Exhibit A - Approved Site Plan

Petition 2020-0005 ASA Conditions of Approval:

Project
K-9 RESORTS
WELLINGTON
PALM BEACH COUNTY FLORIDA

Drawing Title
SITE PLAN

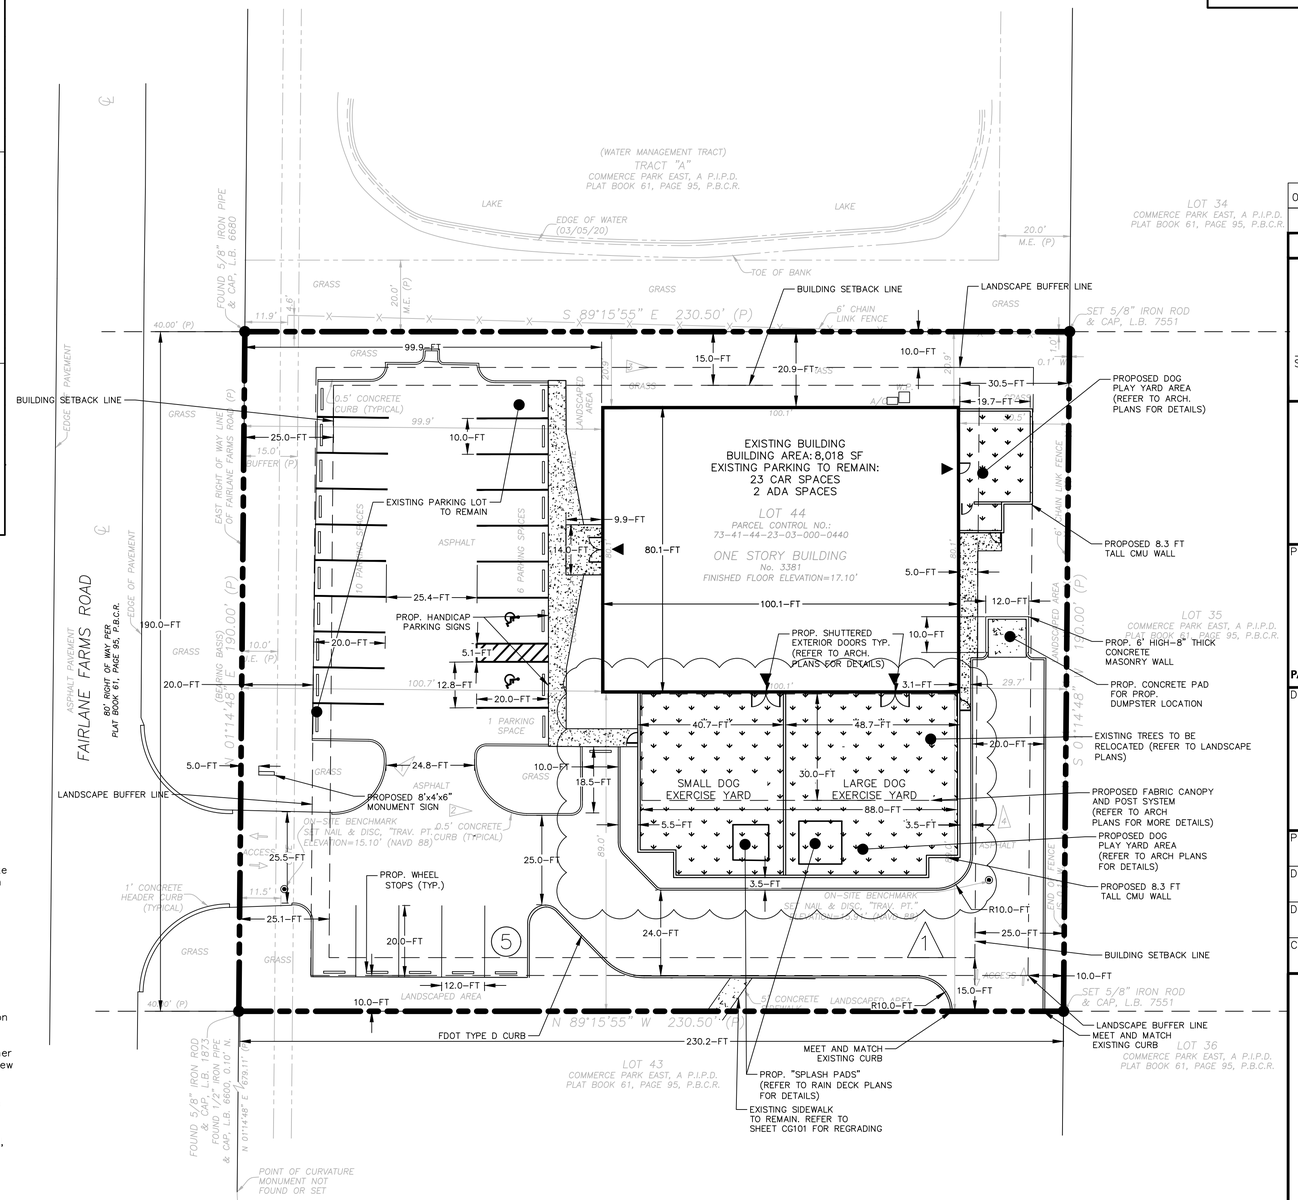
1. All previous conditions of approval shall remain in effect (PLANNING AND ZONING).

2. The site plan meets the requirements of Wellington's Land development Regulations and is certified for the particular site design based on the plans date stamped August 31, 2020. Any changes due to engineering or building permits may require a future site plan amendment. (PLANNING AND ZONING)

3. A permit is required from the Building Department for proposed landscaping throughout the site. The owner/applicant shall ensure dead/missing landscaping (including groundcover) and al proposed landscaping is installed prior to zoning final inspection. (PLANNING AND ZONING)

4. An Engineering Department Permit will be required for all proposed Site Work. Additional comments on the proposed drainage system layout, drainage calculations, and design elements may be forthcoming with the Engineering Department Permit review process. (ENGINEERING).

5. The dumpster area shall be enclosed with walls and automatic closing gates. The owner shall ensure the gates remain closed unless during pick-ups/deliveries or to be services. (PLANNING AND ZONING)

6. Animal waste shall be cleaned and picked up on a daily basis. Waste shall be properly disposed of in the onsite dumpster. Dumpster collection shall be scheduled weekly or more depending on need to limit odors or other nuisances. (PLANNING AND ZONING)

7. As per the Civil Plans, an infiltration system shall be installed underneath the permeable K9 grass to ensure proper filtration of water from the outdoor runs. (PLANNING AND ZONING)

8. All state (if applicable) and local licensing shall be obtained and annually renewed including a commercial kennel license from Palm Beach County Animal Care and Control and business tax receipts from Wellington and the county.

9. All above ground utility equipment, mechanical equipment, transformer box, valves and exhaust vents, etc. shall be completely screened from view while maintaining required clearance. (PLANNING AND ZONING)

10. Prior to the final building inspection and/or issuance of Certificates of Occupancy/Completion, final inspection and approval is required from both the Planning and Zoning and Engineering Departments to ensure compliance with all approved site/landscape plans, conditions or approval, building elevations, architectural details, colors, signage, etc. (PLANNING AND ZONING)
